1955 PITTWATER ROAD, BAYVIEW

S4.55 AMENDED PLANS

DRAWING LIST

Drawing Title
Carpark Floor Plan

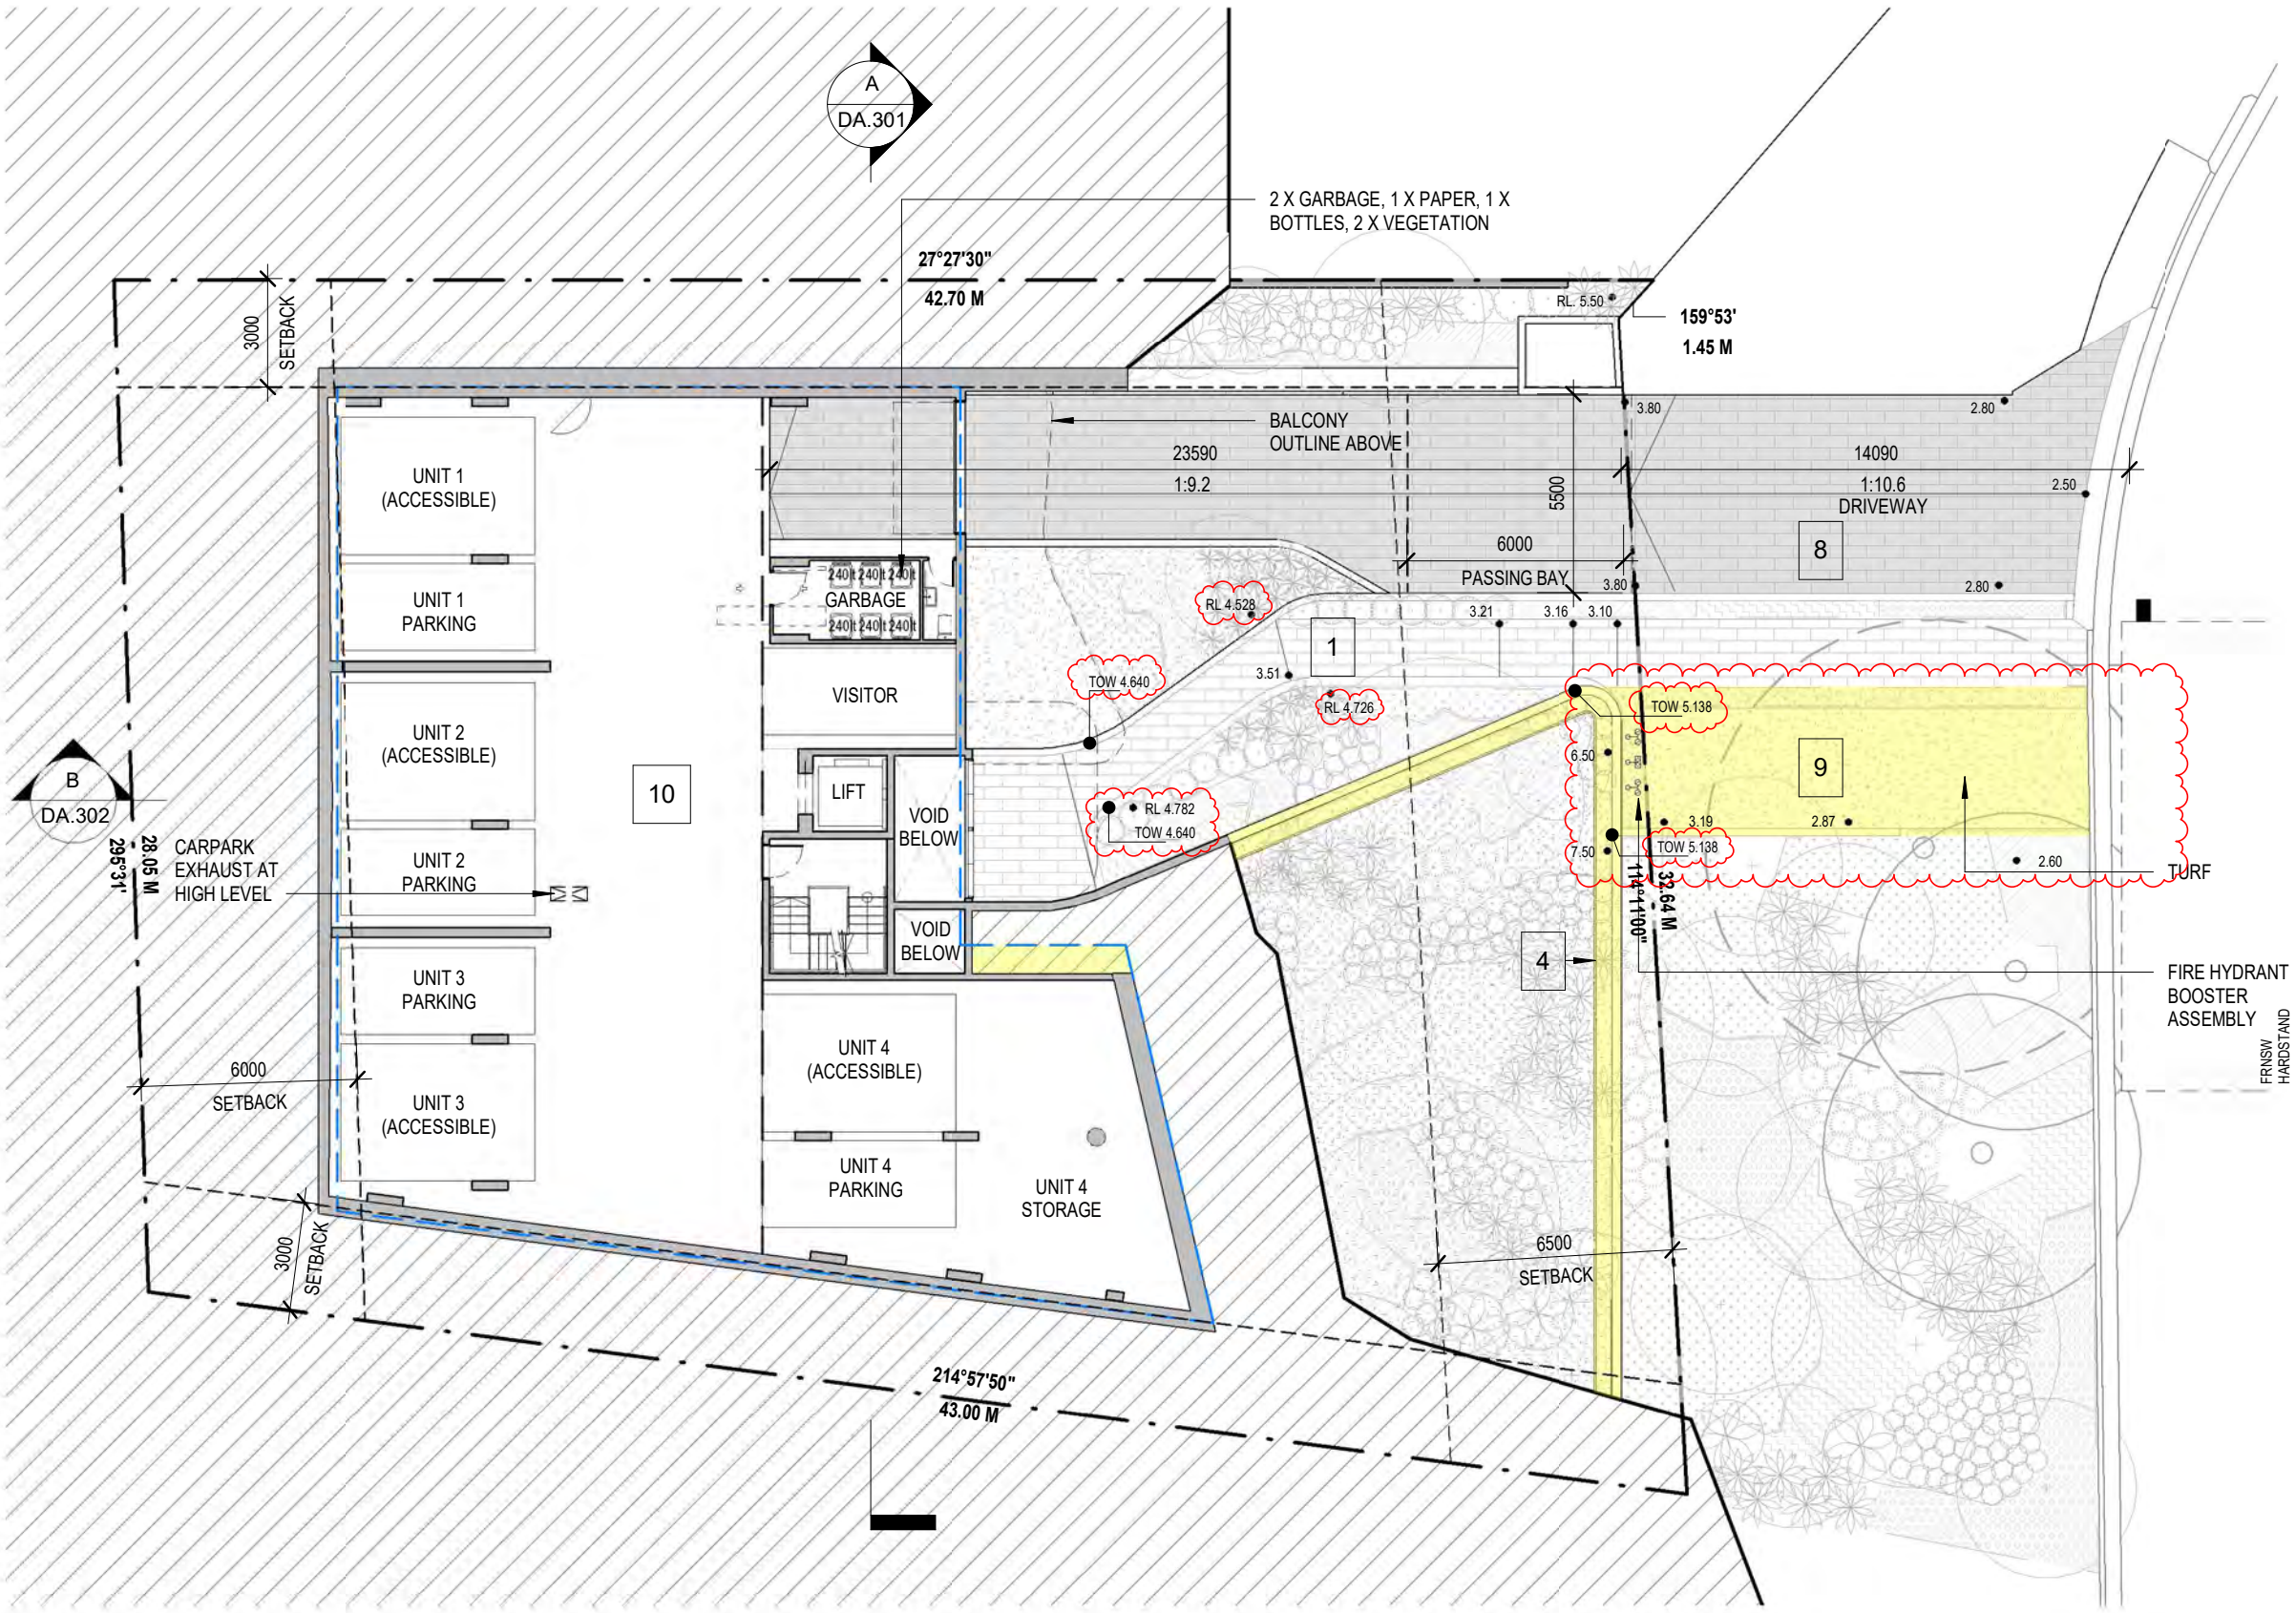
- 9. **FRNSW Requirement** - to provide hardstand & fire hydrant booster assembly, requiring removal of tree T3 (Refer to Arborist Report).
- 10. **Carpark Floor Plan** - Parking re-configuration within approved footprint.

Drawing Title
Lower Ground Floor Plan

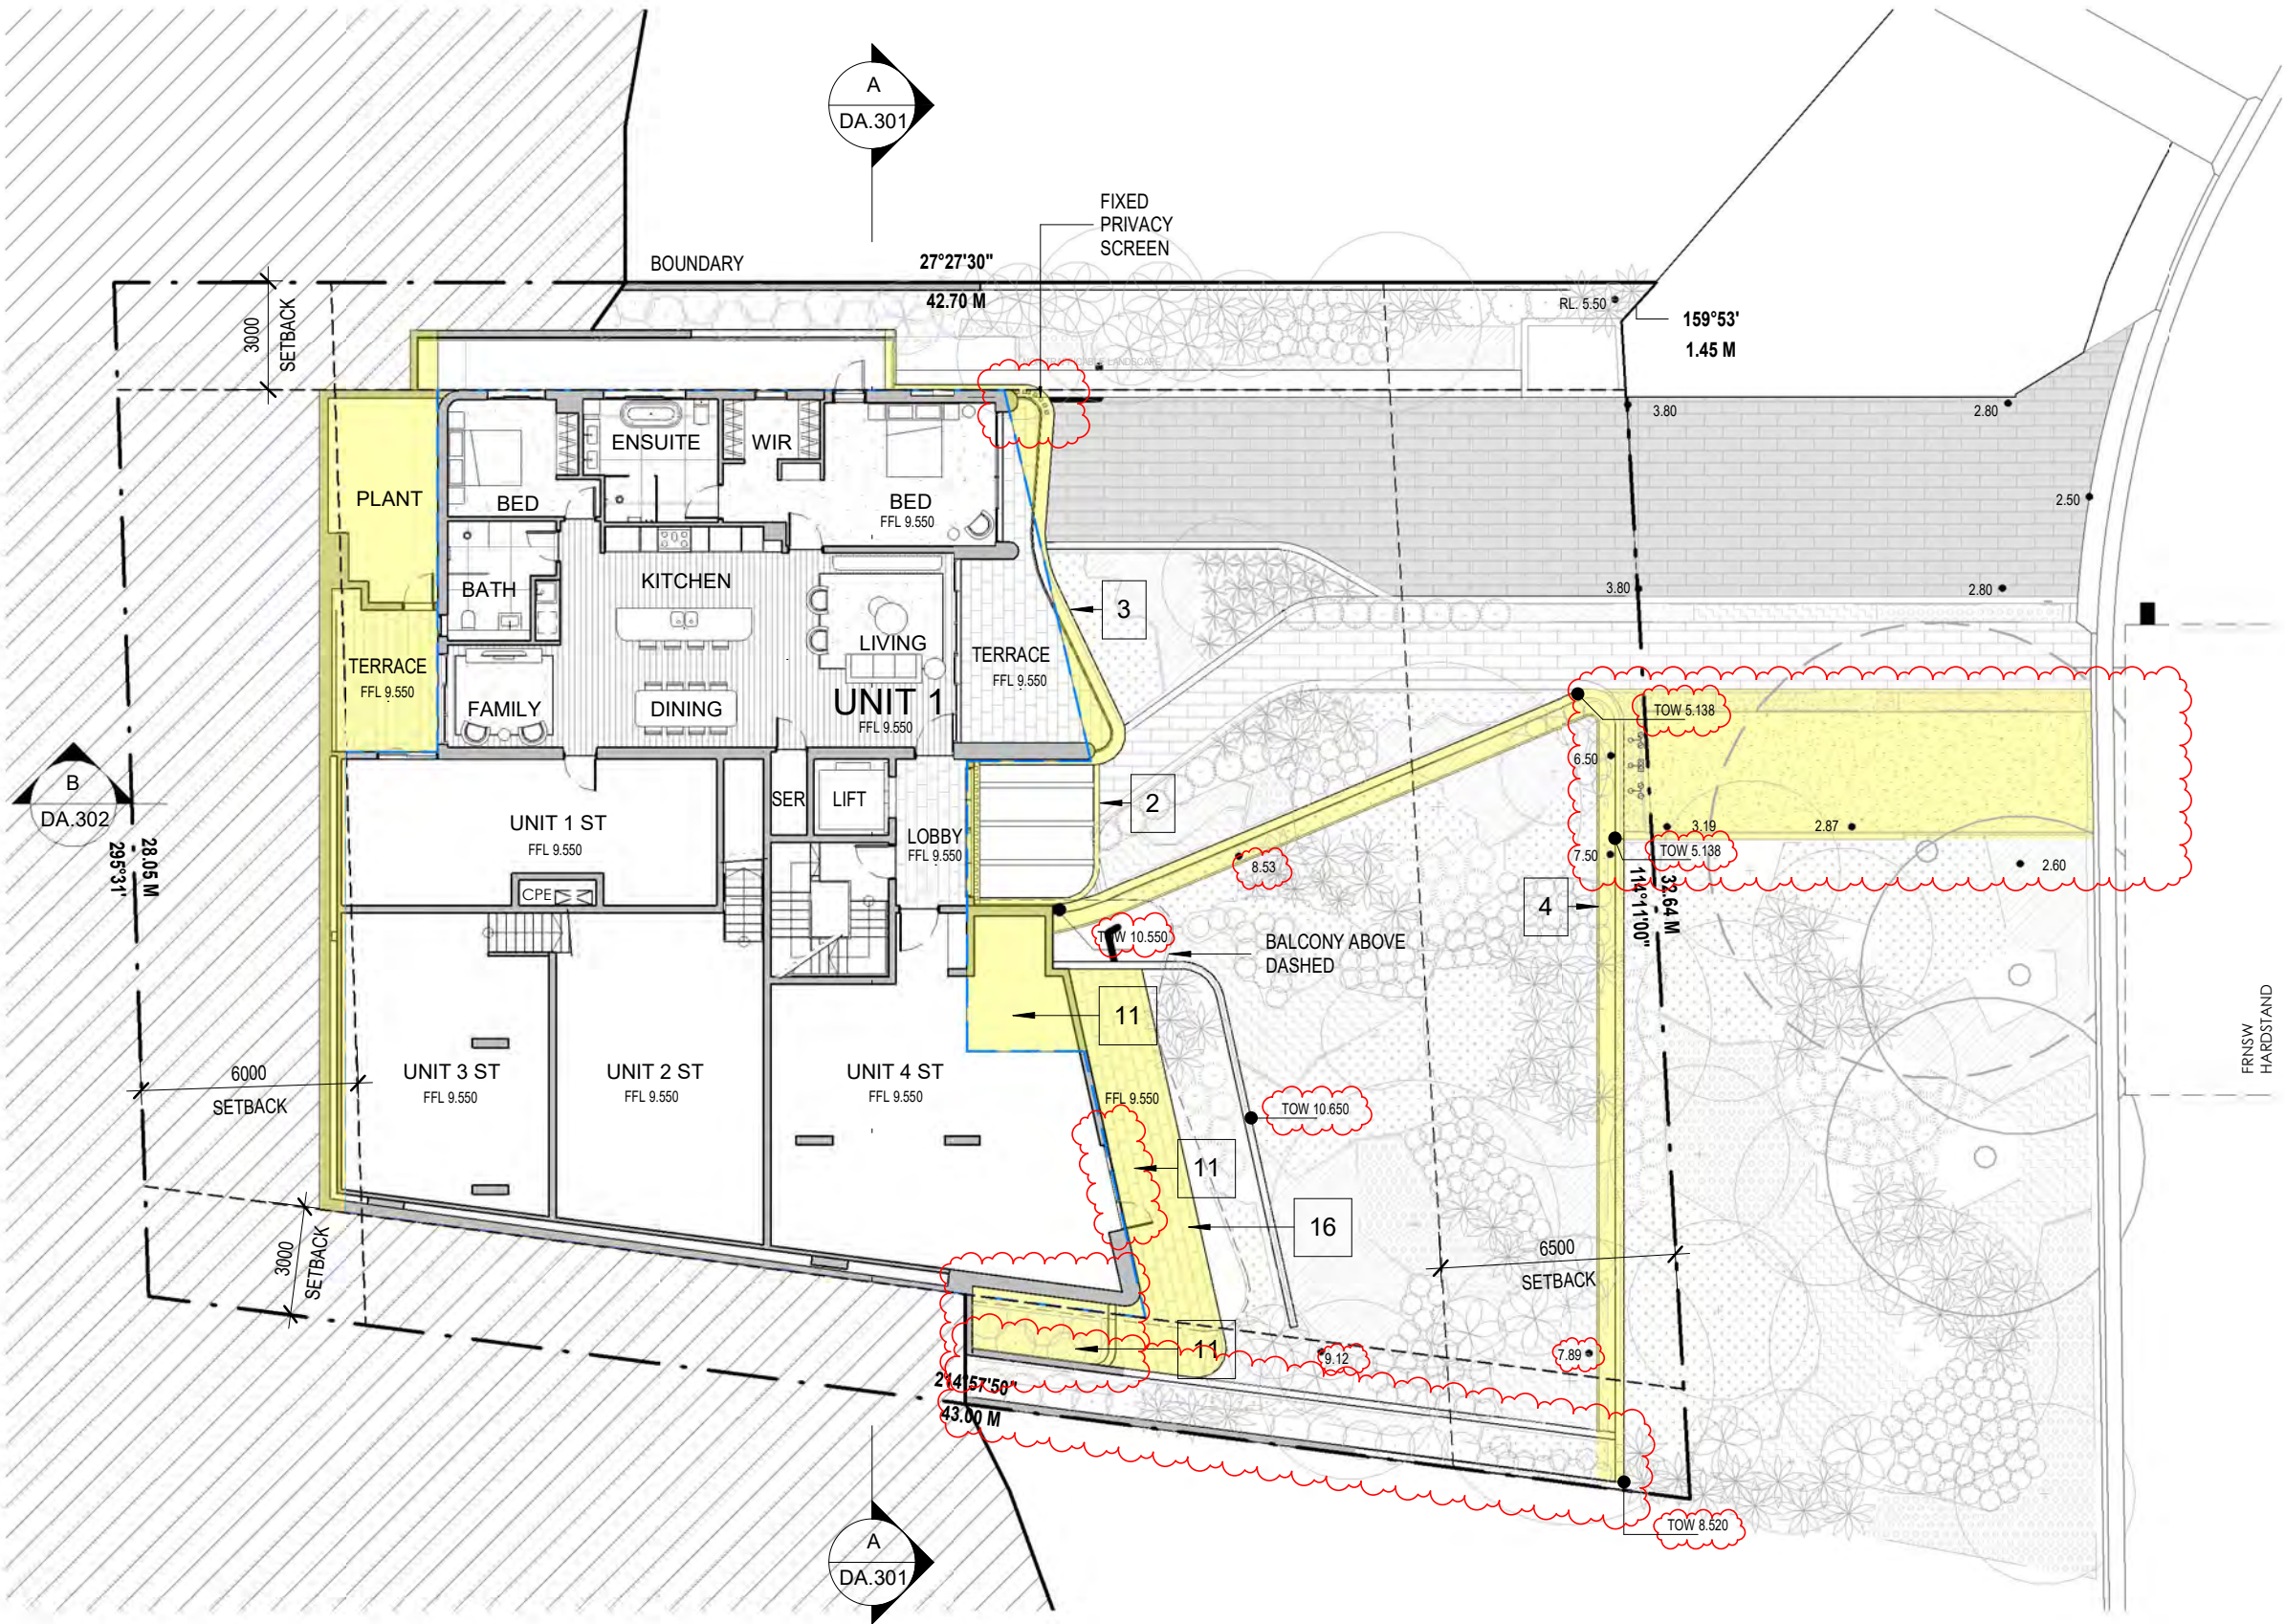
- 11. Lower Ground Floor Plan – Increase in Unit 4 storage area to accentuate recess and alignment between the two modulated built forms. Louvred door and panels for maintenance and ventilation. New landscaped terrace to integrate with cascading balconies above and overall building aesthetics.

Ground Floor Plan

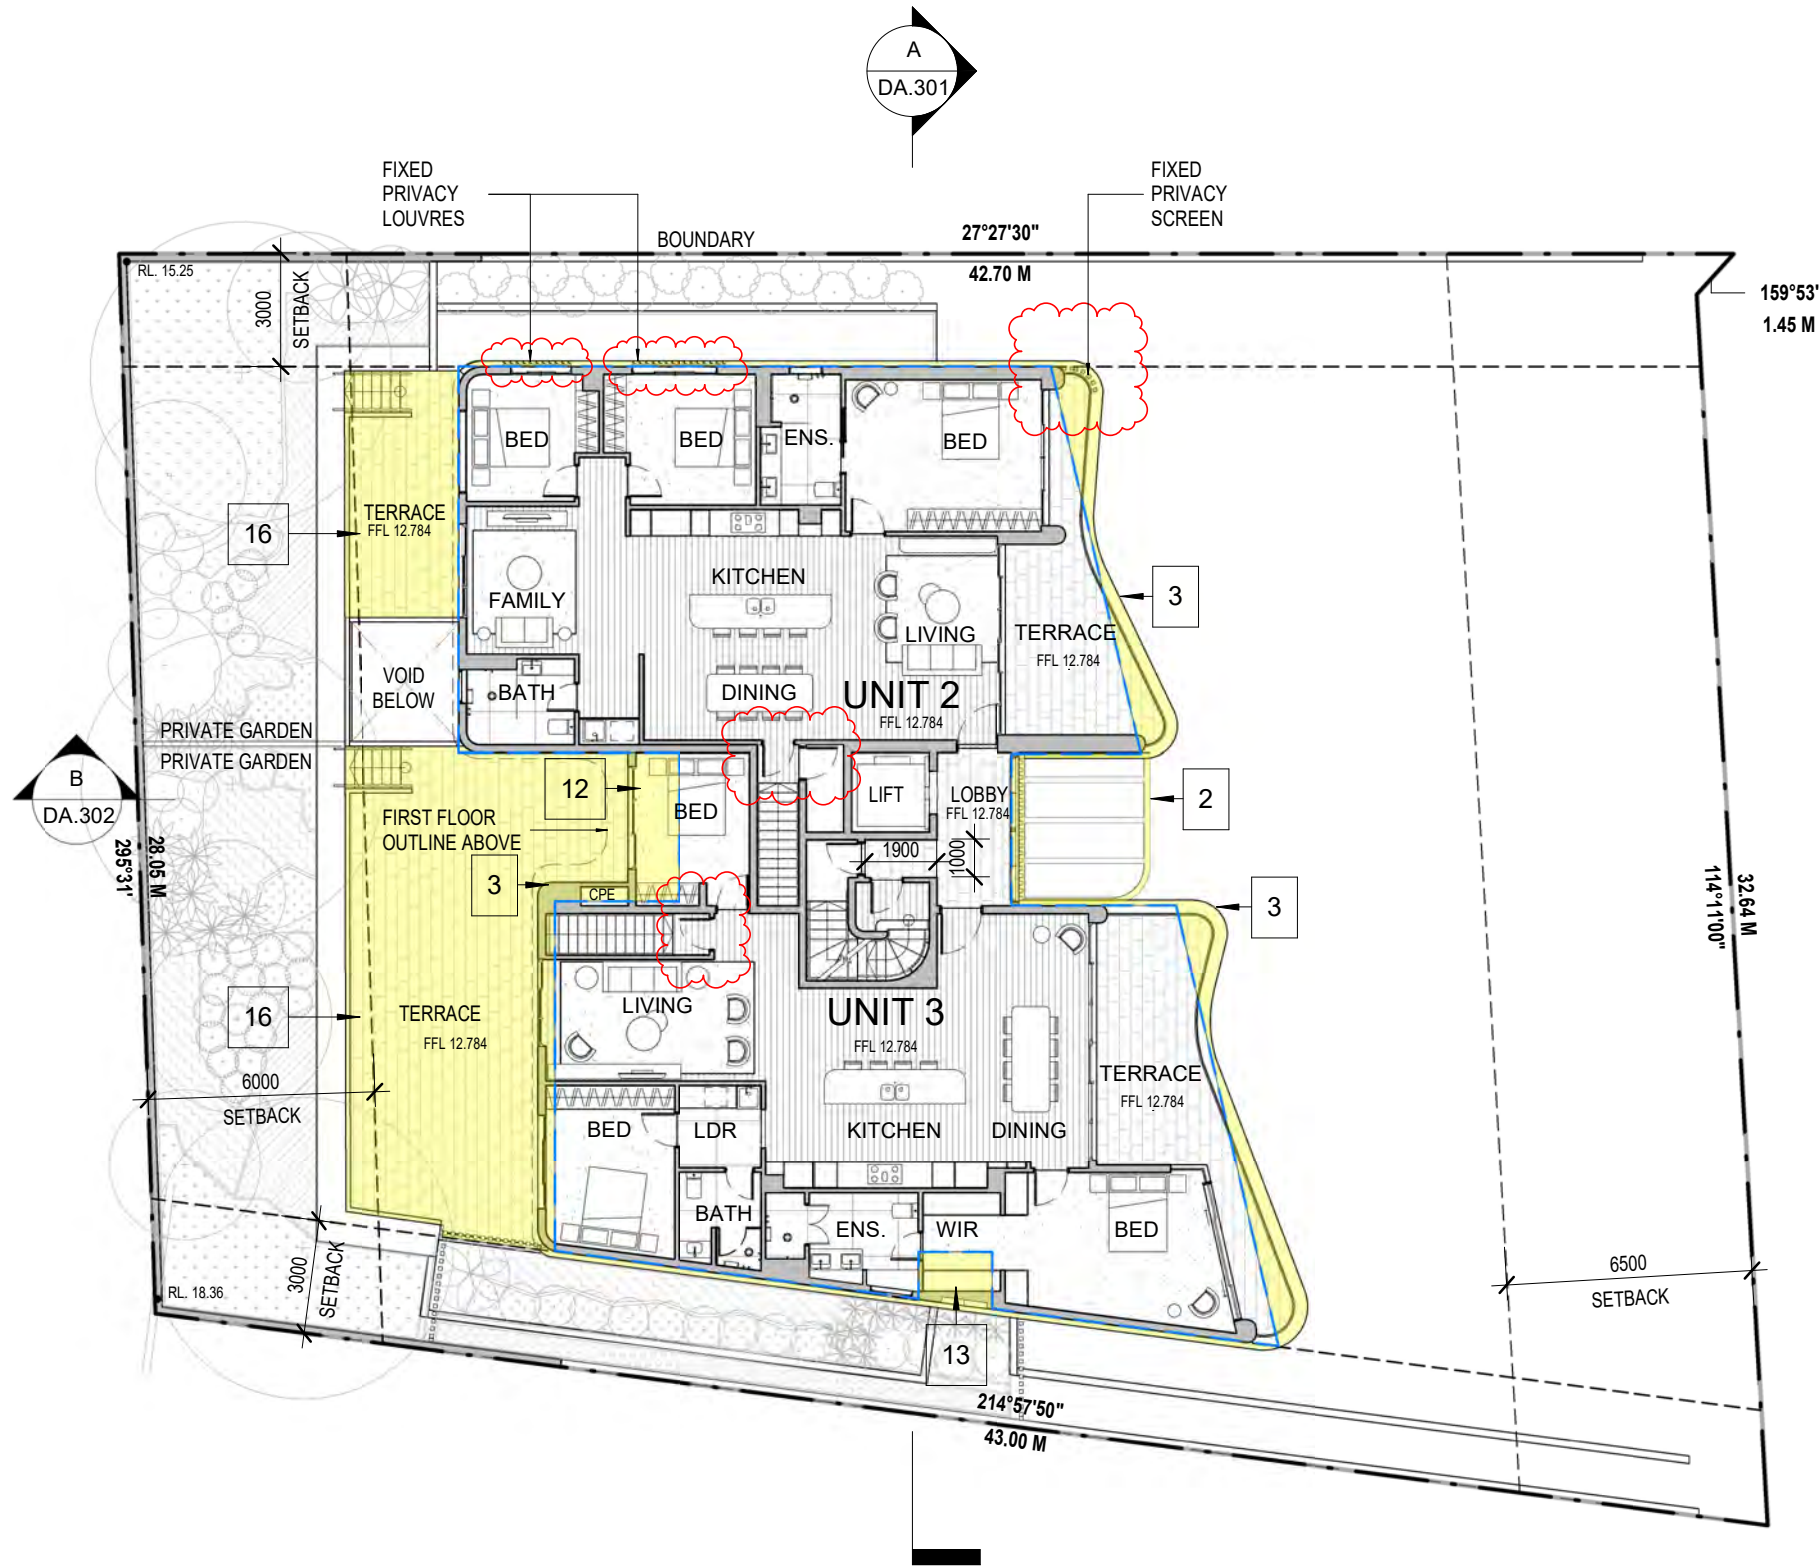
16. Proposed Terrace Extension
